**PLANNED UNIT DEVELOPMENT &
SIDEWALK WAIVER REQUEST
STAFF REPORT**

Date: November 7, 2013

Audubon Properties, LLC.

4700 & 4960 Dauphin Island Parkway
West side of Dauphin Island Parkway, 580'± North of
Marina Drive North).

SITE PLAN

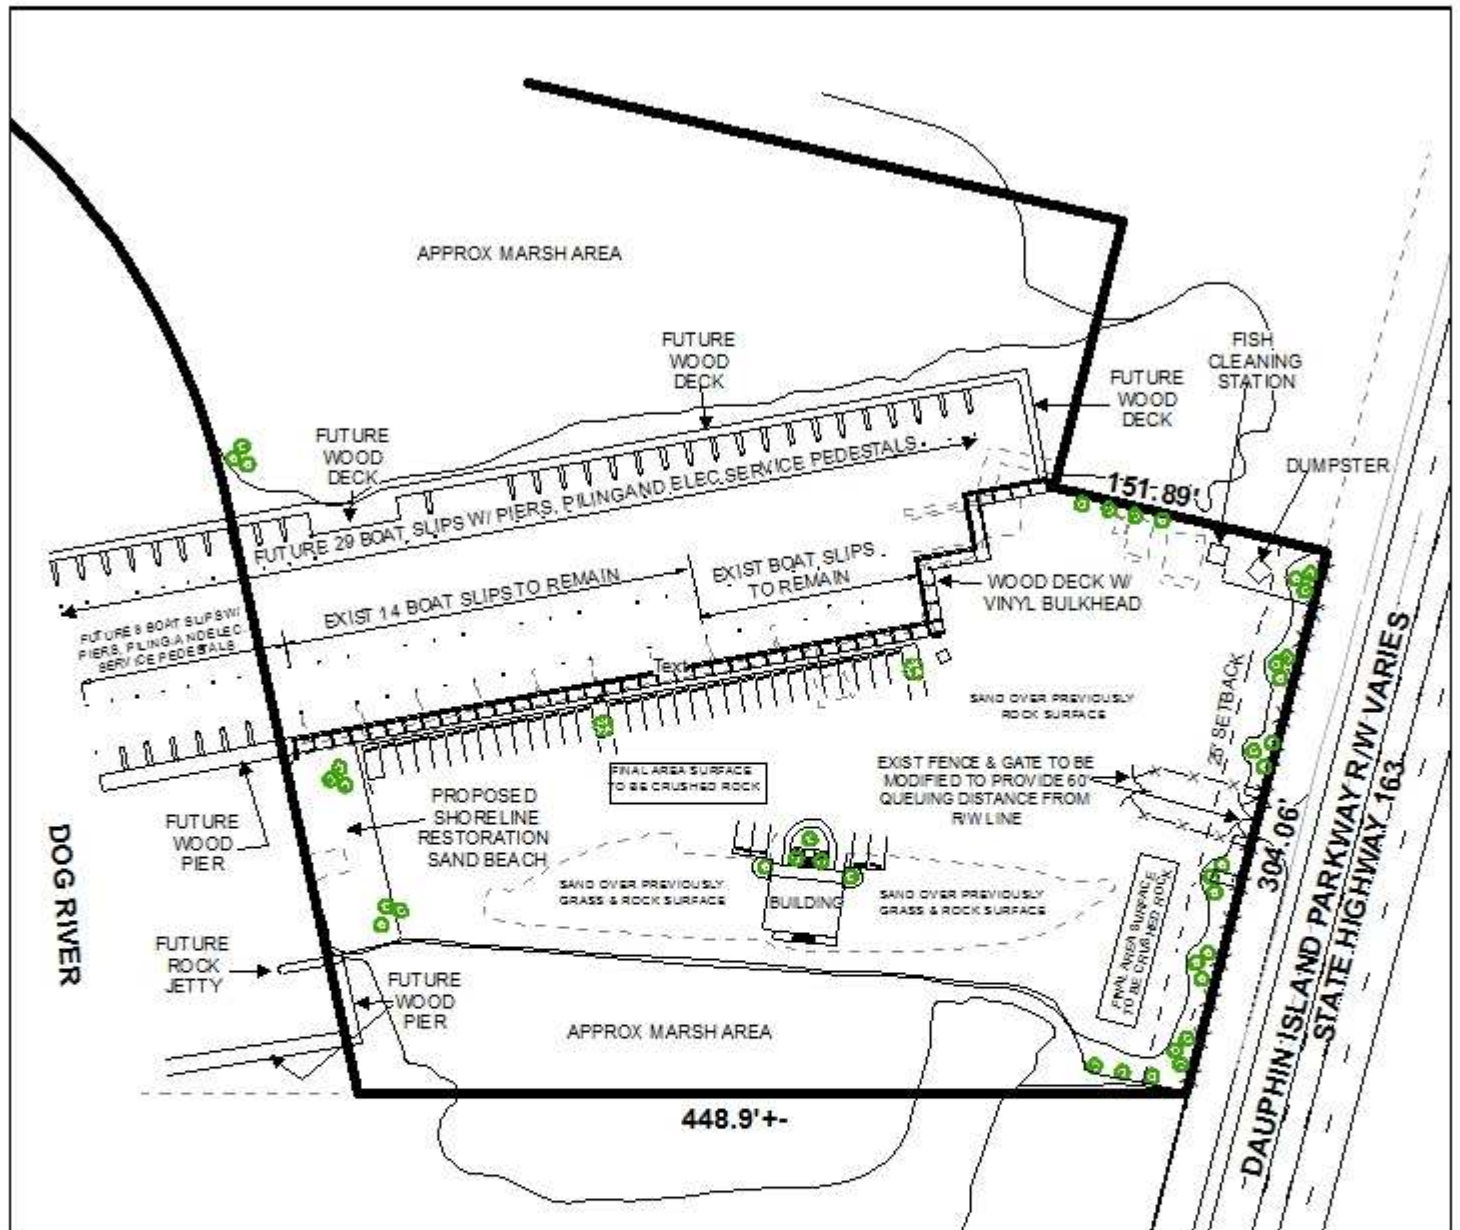
It appears, generally, that the number of parking spaces will be adequate for the proposed use and the site plan depicts each parking space with a wheel stop, however, there appear to be no accessible parking spaces shown on the plan. The applicant should verify if accessible parking will be required. If accessible parking is required, a revised site plan depicting the revised parking spaces will be required.

Regarding the required landscaping and trees, the total lot area provided is 122,145 square feet. The total landscaping required is 14,657 square feet. Of the total landscape area, 60% of it must occur between the street line and the building wall facing the street: 8,794 square feet is required and 11,178 square feet is provided. The site appears to meet the requirements of the Zoning Ordinance, for frontage trees and landscaping. However, site plan states that there are 53 total trees required for the site, whereas there are only 41 trees illustrated on the plan. The site plan should be revised to reflect compliance with the tree requirements of the Zoning Ordinance.

The site currently has an existing iron fence and gate that runs along the right-of-way frontage of Dauphin Island Parkway. The gate should be modified to provide a 60' queuing distance from the right-of-way line. It appears the existing driveway is not 24' wide as required by the Zoning Ordinance, thus modifications should be made to address this issue. The labeling of the right-of-way width along Dauphin Island Parkway should also be illustrated on the site plan.

A screened enclosed dumpster is noted and depicted on the site plan. However, there is no indication that the dumpster will be connected to sanitary sewer. The site plan should be revised to indicate if the dumpster will be connected to sanitary sewer and if so, the dumpster pad must comply with any regulations pertaining to location in a flood zone. All other notes displayed on the site plan should be retained on any revised plans.

1. submission of a subdivision application;
2. revision of the site plan to illustrate accessible parking spaces;
3. revision of the site plan to depict correct calculations of trees or the number of trees illustrated on the site plan;

4. revision of the site plan to show the relocation of the existing gate to provide a 60' queuing distance from the right-of-way line;
5. labeling of right-of-way width of Dauphin Island Parkway on site plan;

6. revision of the site plan to indicate a driveway width of 24';
7. placement of a note on the site plan stating that approval of all applicable Federal, state and local agencies is required for endangered, threatened or otherwise protected species;

9. revision of the site plan to indicate if the dumpster will be connected to sanitary sewer;
10. retention of all other existing notes on any revised plans;
